Memorandum

Subject: Case File: LU 19-225732 SOWA Alamo Manhattan Blocks
Otak Responses to Land Use Review Comments dated November 21, 2019

Otak Project No.:19050.100

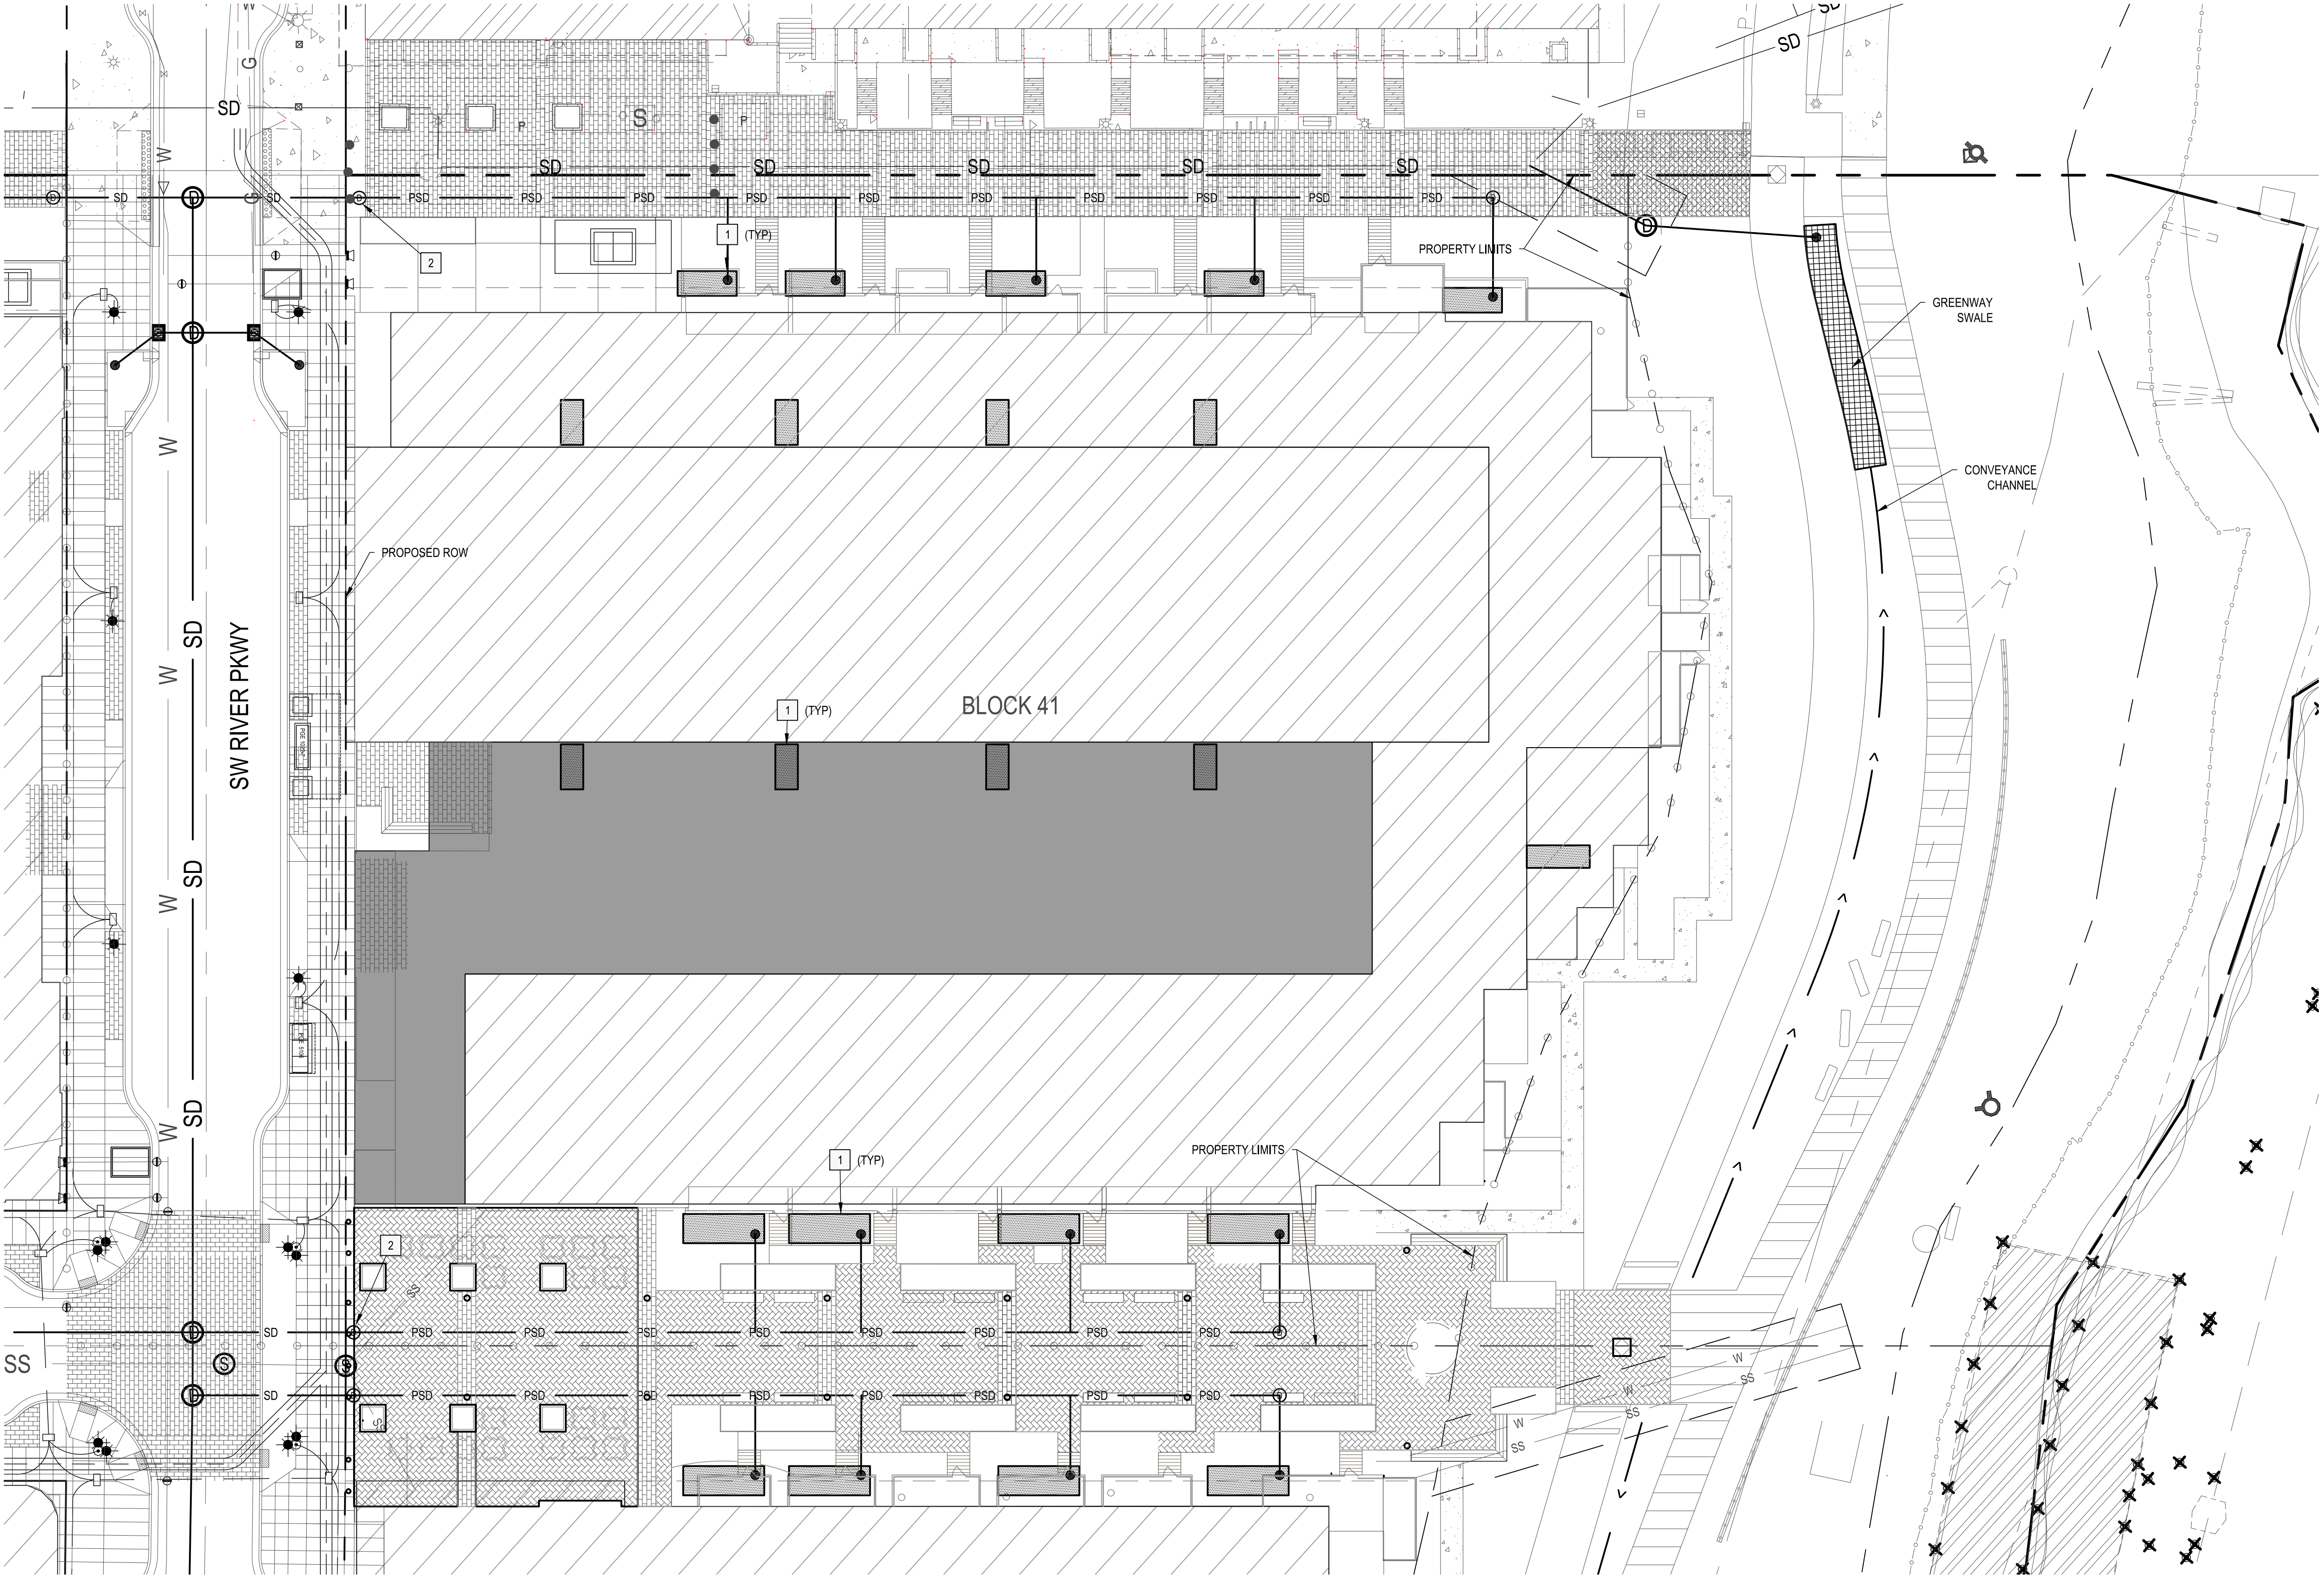
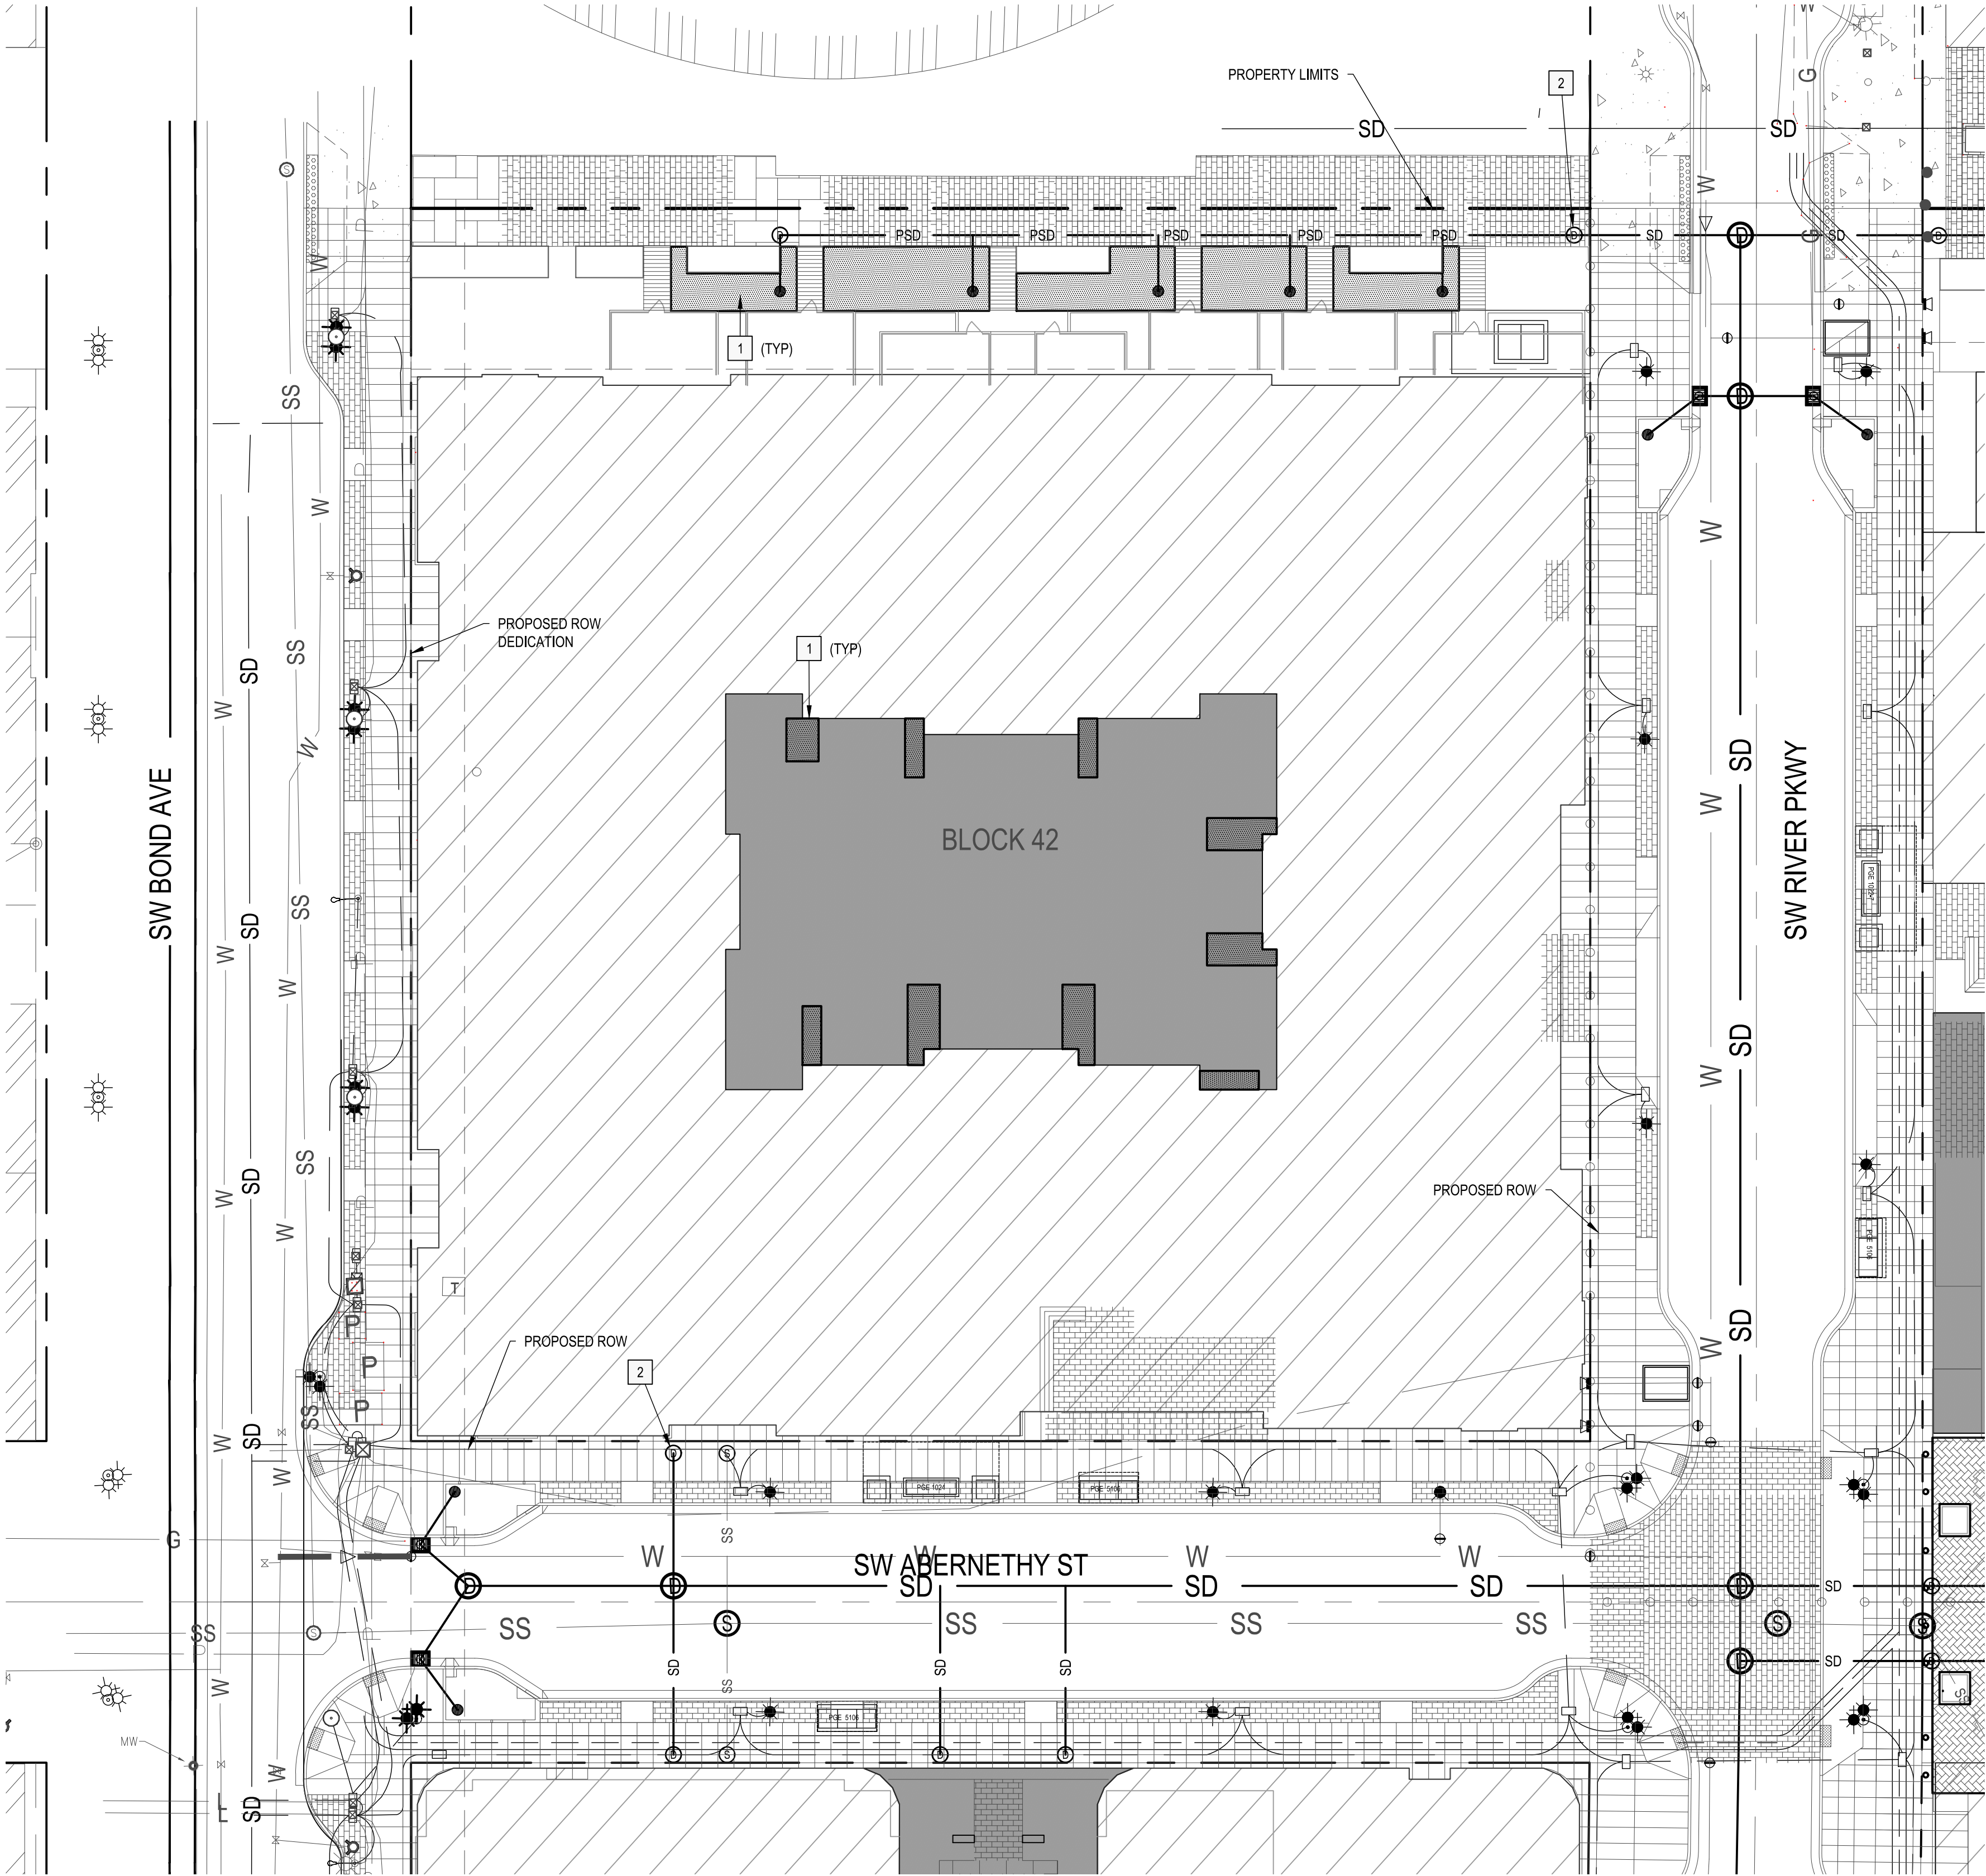
- 1)** *The stormwater report Figures 2.1 – 2.4 (exhibits C.124, C.125, C.126, C.127) as well as the Stormwater Plan figures (exhibits C. 116, C.117, C.118, C.119) provided in the design review package show ecoroof coverage for each building which is inconsistent with the stormwater report narrative. Ecoroofs are required on new buildings in the Central City Plan District (Portland City Code 33.510.243) and should be accounted for in the stormwater management plan.*

- 2) *Figures 2.1 – 2.4 of the stormwater report indicate the lined flow-through planters are managing non-ecorooft areas only and this is inconsistent with the narrative. Therefore, it is unclear if the applicant intends to only manage stormwater with lined flow-through planters or if stormwater will also be managed by ecoroofts. This information should be provided as changes to the size and location of the lined-planters could impact the design and layout of the site.*

A revised Design Review Conceptual Stormwater Management Plan will be resubmitted to show consistency between the report and the updated building/greenway plans. Note, as discussed with City BDS Planning staff, the project team is resubmitting the DR application under Title 33 code that went into effect on March 1, 2017. This eliminates the code requirement for ecoroofs that were provided in the original submittal. The reduction of ecoroofs on the project will impact the stormwater strategy in that we will utilize (and try to maximize) raised flow-through planters at intermediate roof levels and ground level for specific areas of non-ecoroof runoff. We will continue to use flow through planters at ground-level plaza and pedestrian access areas as the site design allows. We will incorporate stormfilter catch basins/vaults/downspouts (mechanical treatment) within each block for water quality treatment of areas not treated by vegetated facilities. These are typically at plaza areas that cannot accommodate the depth of required LIDA facilities (planters) due to conflicts with garage structure below plaza areas. Our proposed stormwater treatment design considers contributing

areas, collection locations, depth of facilities, outlet locations, and conveyance to storm laterals to the public storm system in adjacent streets.

We have attached preliminary exhibits for each Block that show stormwater treatment areas and facilities proposed for the four blocks. A revised Design Review Conceptual Stormwater Management Plan will be submitted to support the revised stormwater strategy for the project.

See response to 3.a.1 above. The amount of ecorooft will be reduced with the Design Review resubmittal. The use of conventional roofs on this project will increase the impervious area to managed on-site and a revised Design Review Conceptual Stormwater Management Plan will show the use of raised flow-through planters, ground level lined flow-through planters, and stormfilters to meet the stormwater treatment requirements on each block. The design will utilize raised flow-through planters at intermediate roof levels and ground levels to treat specific areas of impervious roof runoff.
